# VALIDATION REPORT FOR THE CORDILLERA AZUL NATIONAL PARK REDD PROJECT

<b>Project Title</b>	<i>Cordillera Azul National Park REDD Project</i>
<b>Version</b>	1.0
<b>Report ID</b>	<i>25 January 2013</i>

<b>Report Title</b>	Validation Report for the Cordillera Azul National Park REDD Project
<b>Client</b>	Centro de Conservación, Investigación y Manejo de Areas Naturales – Cordillera Azul
<b>Pages</b>	47
<b>Date of Issue</b>	1 February 2013
<b>Prepared By</b>	SCS Global Services
<b>Contact</b>	2000 Powell Street, Suite 600, Emeryville, CA 94608, USA <a href="http://www.SCScertified.com">http://www.SCScertified.com</a> Email: <a href="mailto:cpollet-young@SCScertified.com">cpollet-young@SCScertified.com</a> Telephone: +1 (510) 452-8000
<b>Approved By</b>	<i>Christie Pollet-Young</i>
<b>Work Carried Out By</b>	Ryan Anderson, Lead auditor Francis Eaton, Auditor

Figure. Years on x axis, district population on y axis. Census data from 1993, 2005 and 2007. INEI (2007) population projections from 2008-2015.

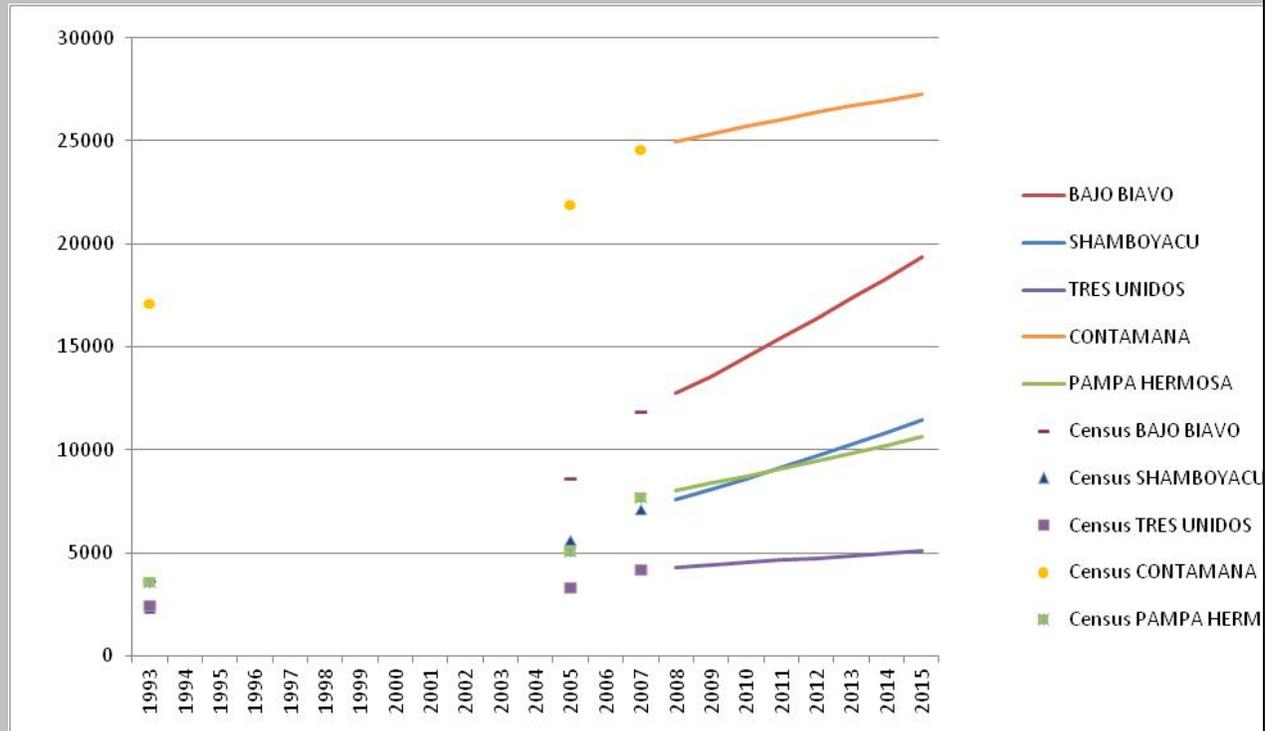
**Finding:** The population projections calculated in cells H5:R20 of the "Projections pop defor" worksheet are based on only the population data from years 2005 and 2007 and do not incorporate the 1993 data that was used to establish that population growth rates had increased in some districts across three census periods. That is, in the nomenclature of equation (11) of BL-UP,  $t_2=2007$  and  $t_1=2005$ . Please justify the use of  $t_1 = 2005$  rather than  $t_1=1993$ , considering the VCS principals of accuracy and conservativeness. Please clarify how basing the population projections on the growth rate observed in the two year period from 2005 to 2007 is more accurate or conservative than incorporating a growth rate calculated over the entire period of data analyzed.

Looking specifically at some of the districts for which the project baseline modeled exponential population change, it is clear that the linear projections of INEI ignore historical evidence of increasing periodic rates.

By comparison, the population modeling approach employed in the project baseline applied exponential rates, where justified, and models population at the district level (a “ground up” or aggregative approach), implicitly incorporating changing distribution of population as is expected in an area subject to high immigration rates.

**Auditor Response:** The project proponent demonstrated that there have been significant improvements in infrastructure surrounding the project area during the time period of the analysis, making the later range of dates more accurate for projecting population growth than a range that includes the time period prior to the infrastructure improvements.
